Sketch shewing amendment to length of
Nos 2 & 3 Hatchways (13 frame spaces instead of 12)

Irvine S.B. & D.D. & Co. Ltd.

S.S. No 556.

Alteration to Nos 2 & 3

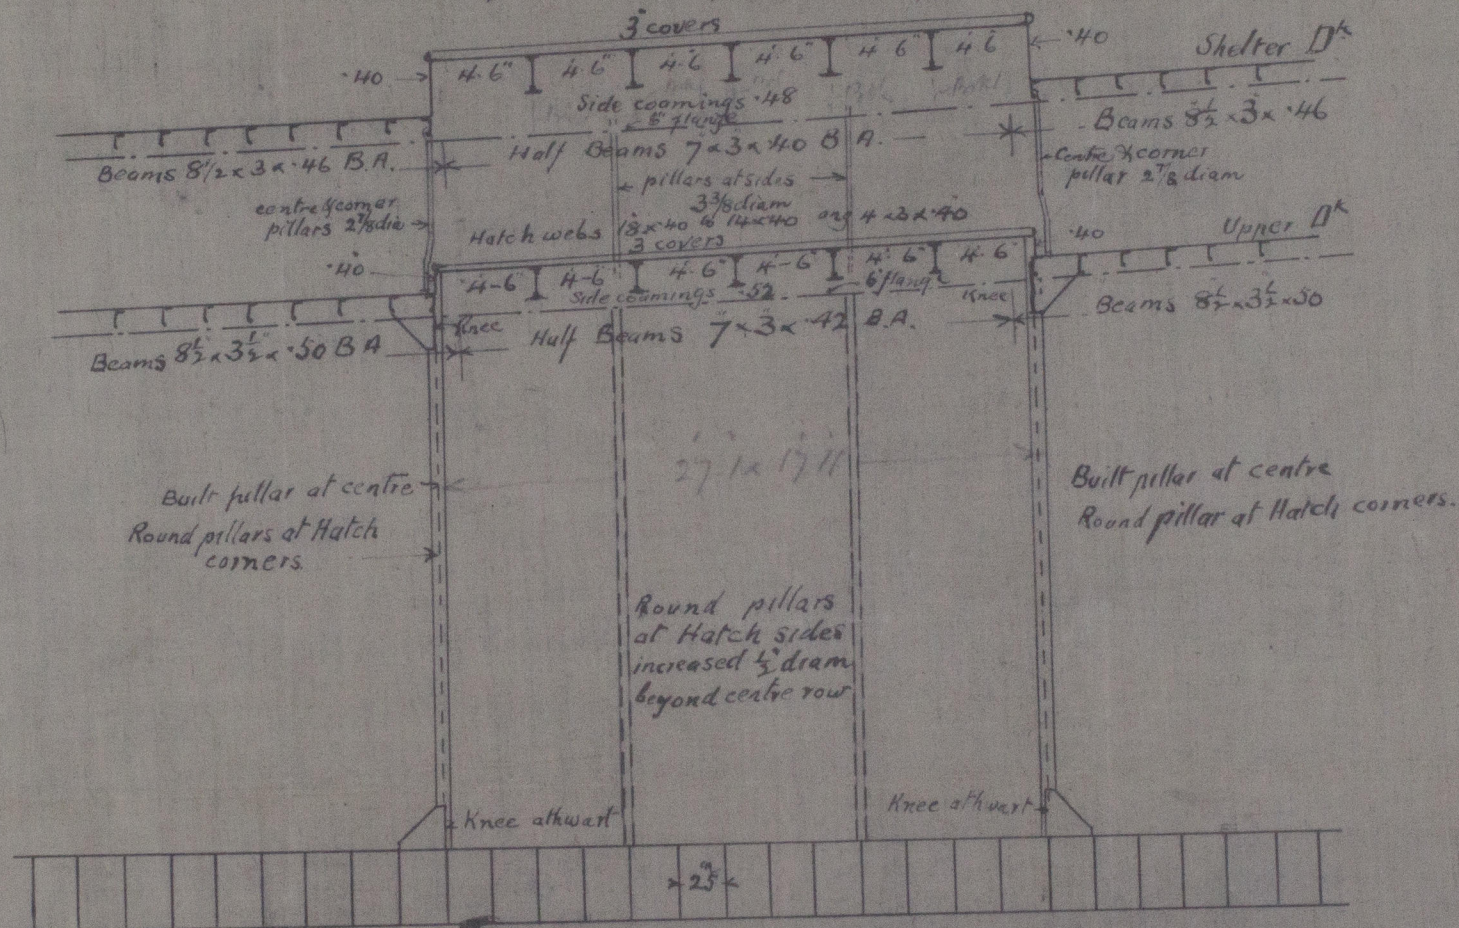
Hatch Webs 18×34 at centre to 14×34 at ends with brackets
mountings dble top & bottom $4 \times 3 \times 40$

Corrected to Lloyds approved plan
29.1.15
